Ref: Hardee Power Station Transmission Line - Vandolah - Arcadia Segment.
Certification # PA 89-25.

DER INSUFFICIENCY RESPONSE

Hardee Power Station - Vandolah to Arcadia Transmission Line
Certification PA 89-25

WETLAND "VV" PLAN/PROFILE

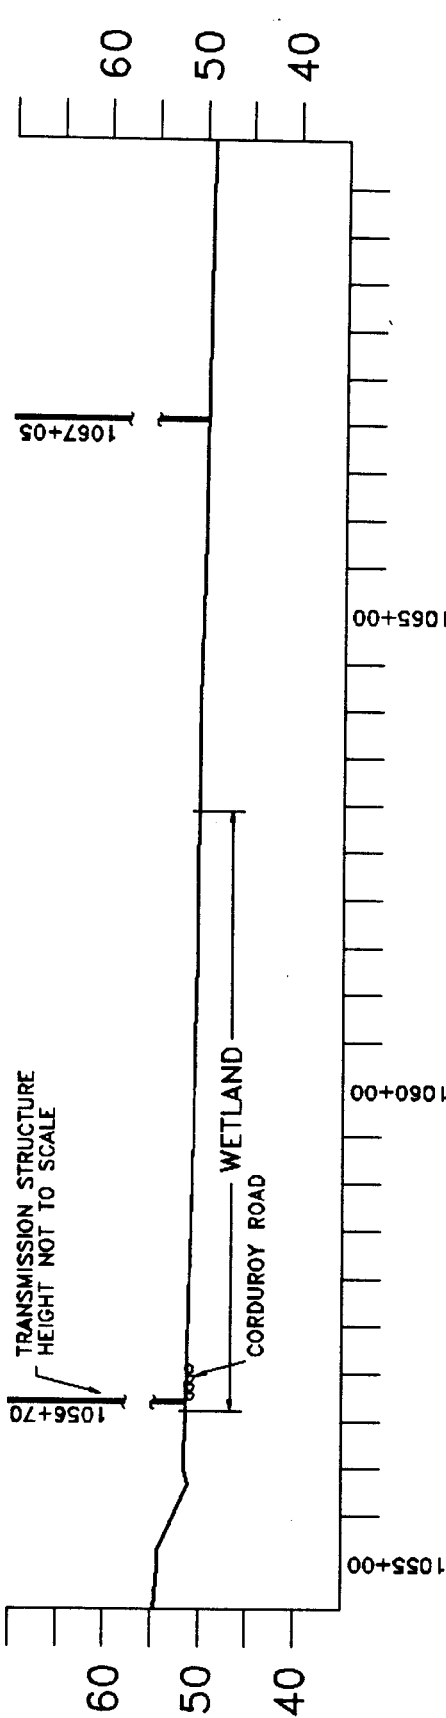
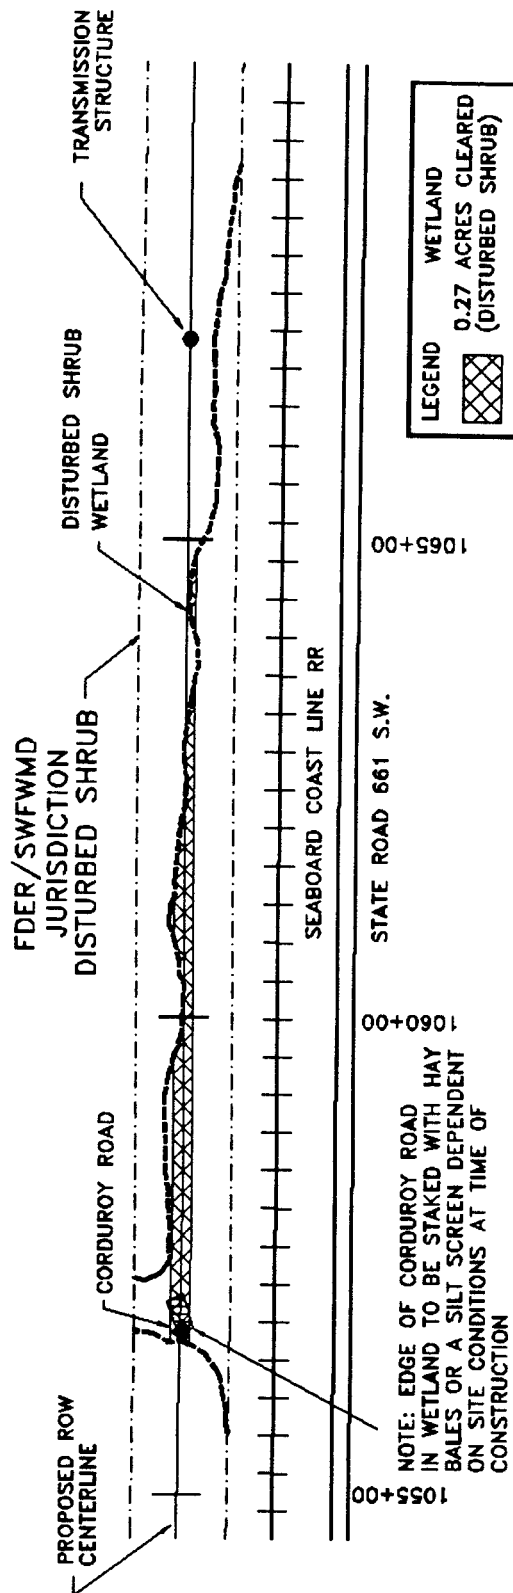
2. *Please clarify why such a short stretch of corduroy road is proposed for wetland VV.*

Wetland VV is a highly disturbed system that has been ditched. This ditched area is the location of the proposed corduroy road. The portion of the wetland that will be required for access (see the attached revised drawing) is normally dry and will not be significantly disturbed.

SEMINOLE ELECTRIC WETLAND RESTORATION/CREATION FIGURE 3 SLOUGH 2

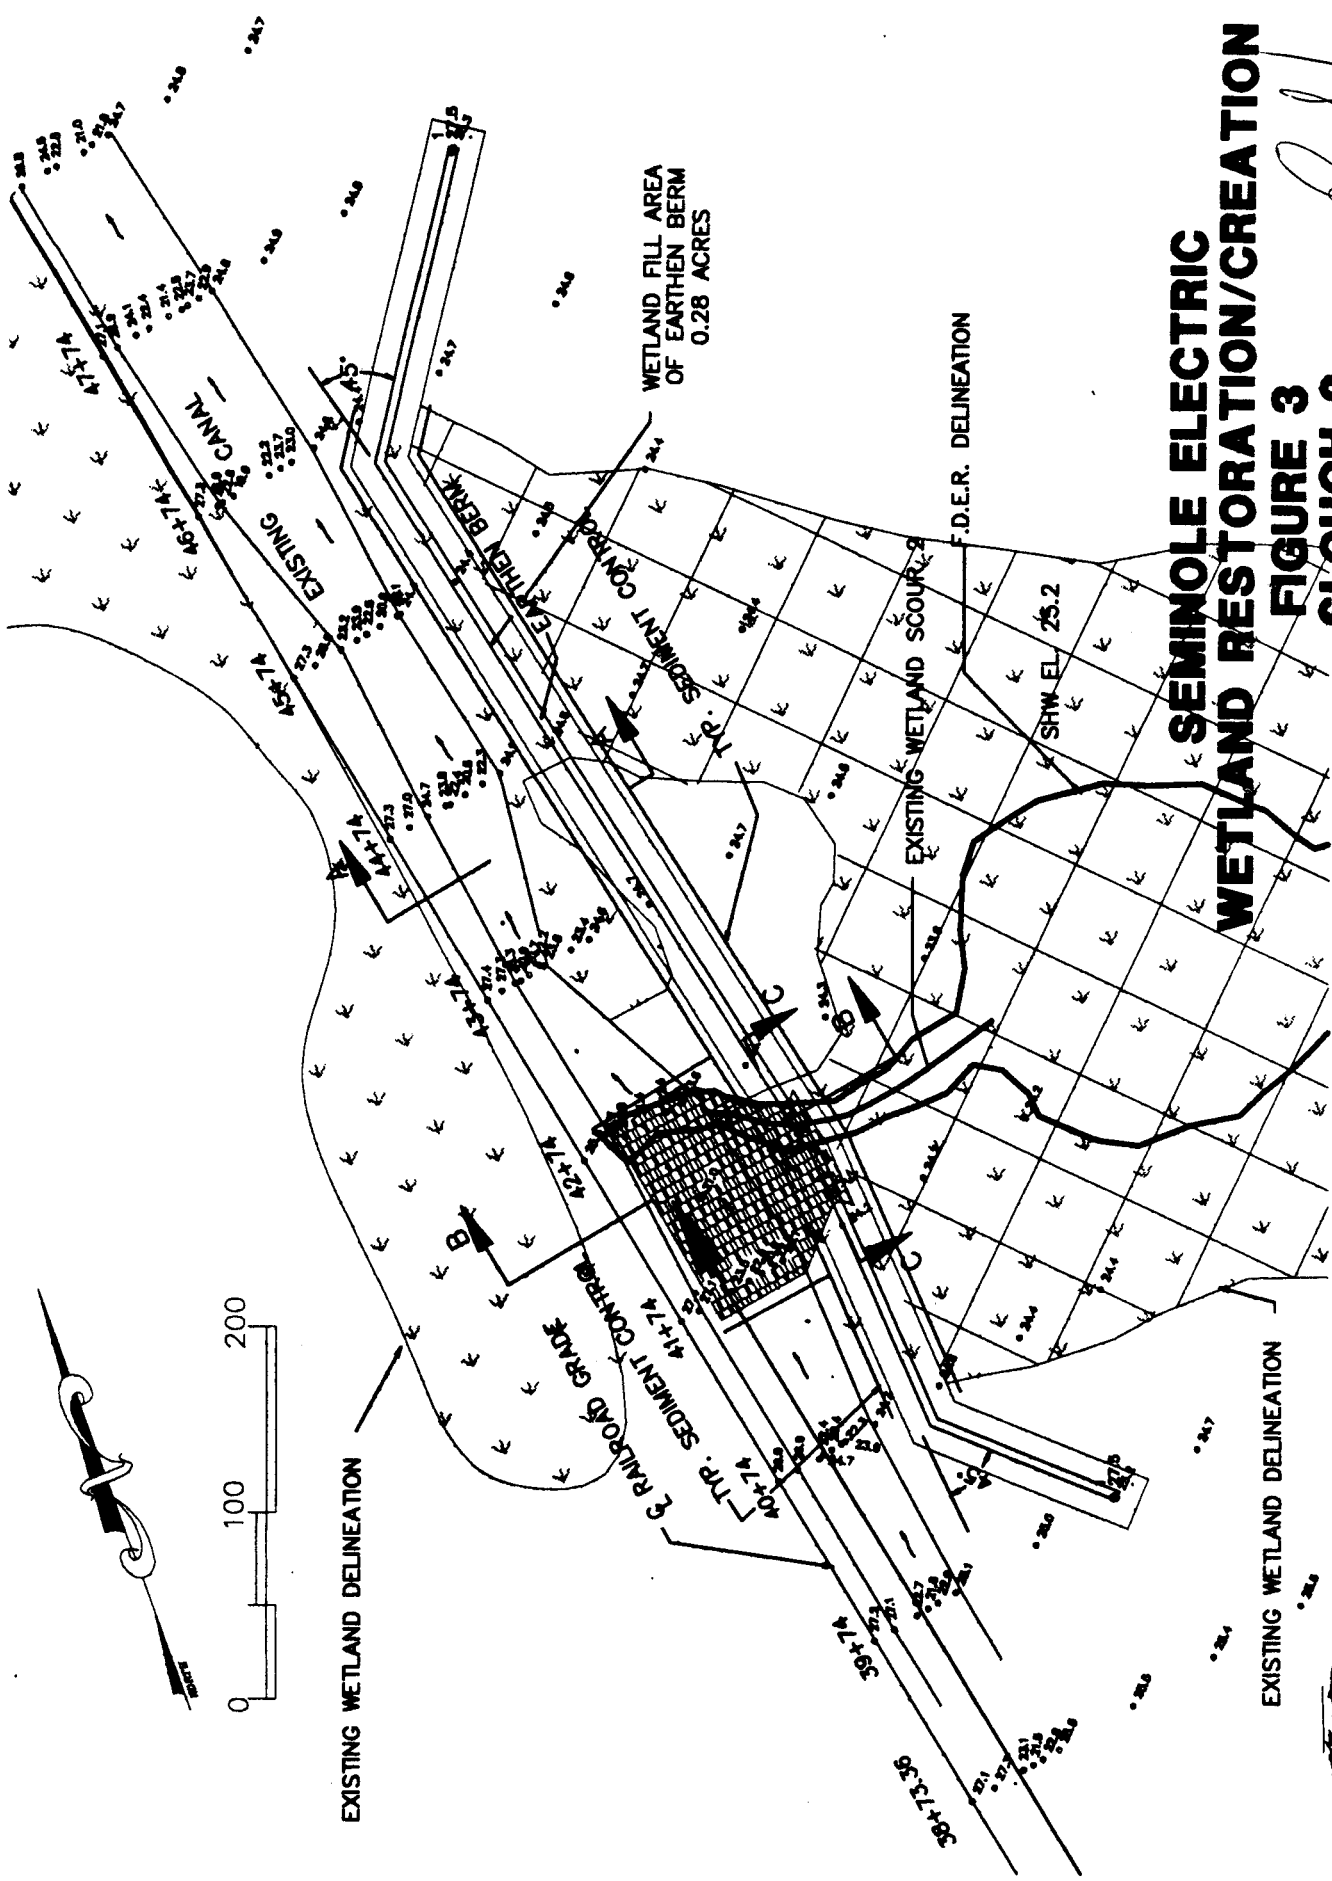
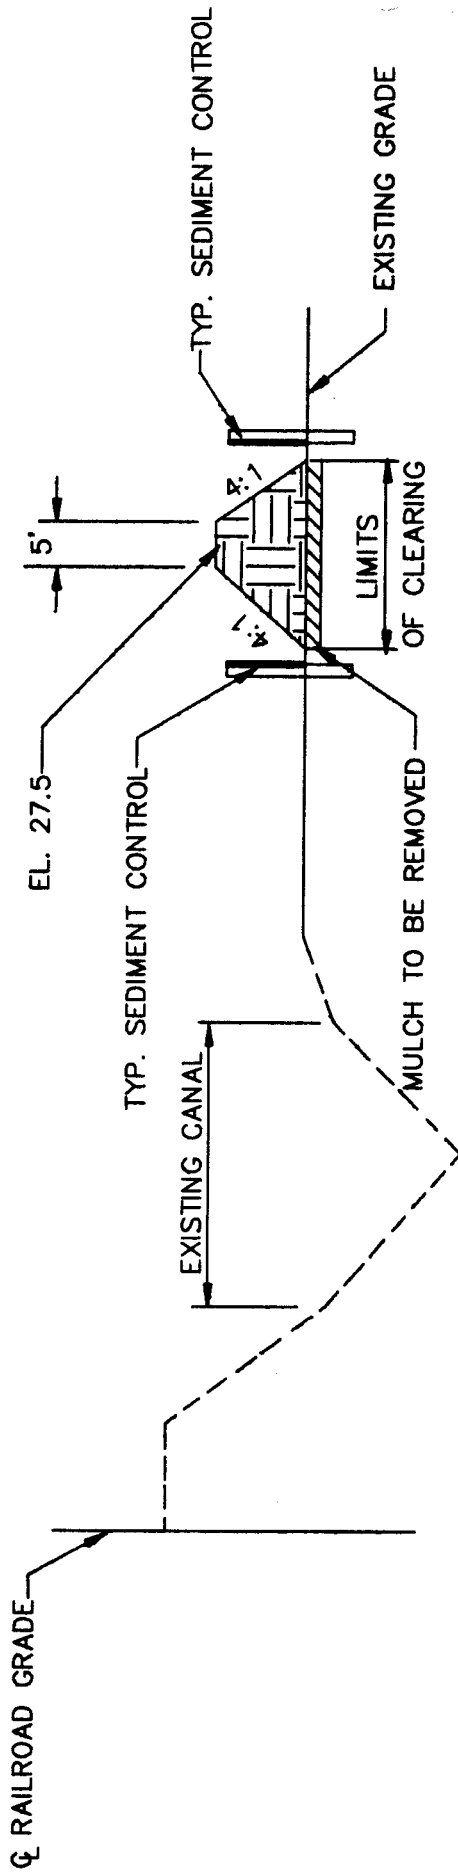
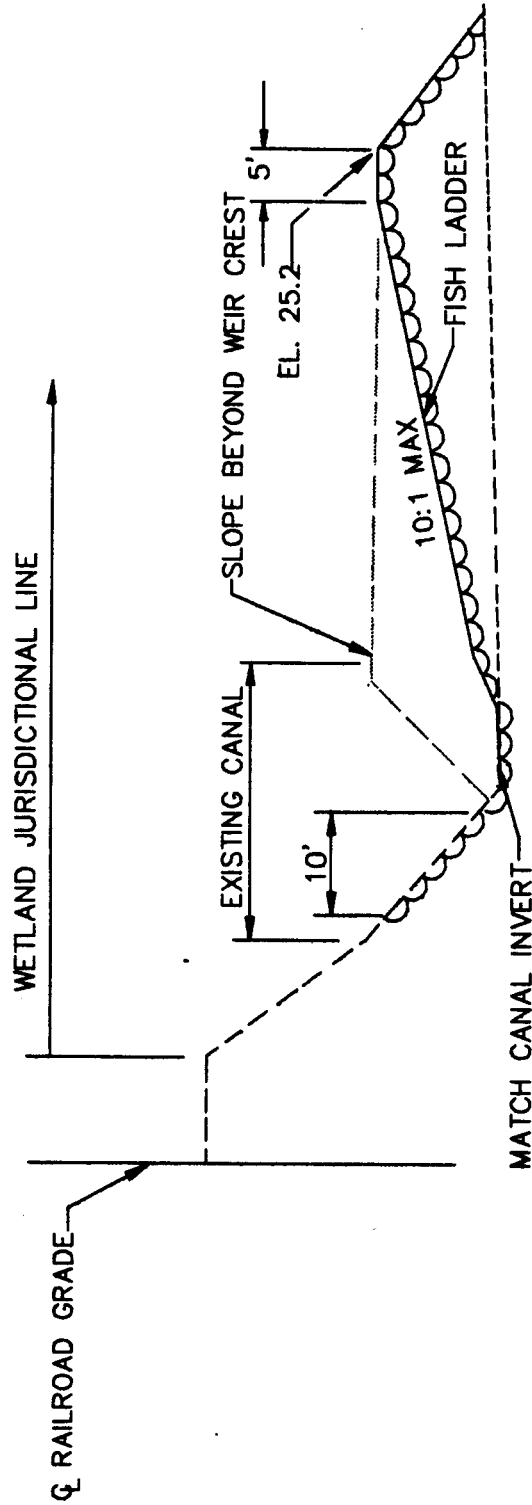
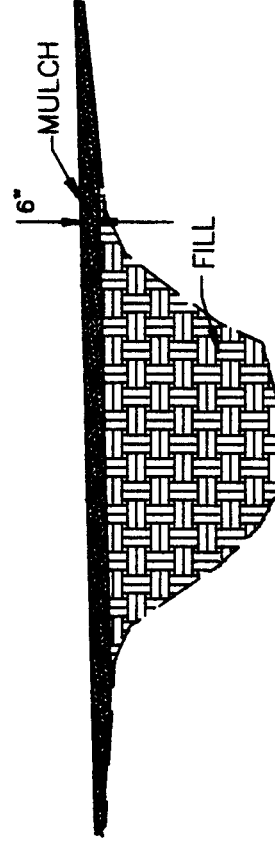
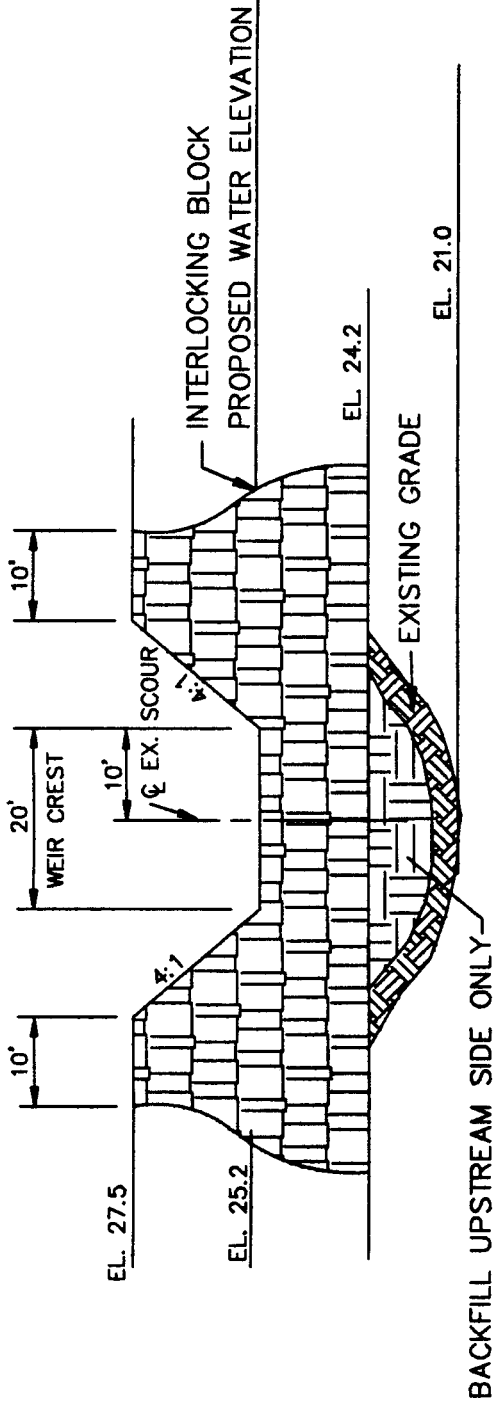
6. *The permit and construction drawings are not consistent regarding the weir elevation at Slough No. 2, and the sections on the construction drawing conflict as well. Please clarify this.*

Please see the attached revised drawings that have corrected the elevations.
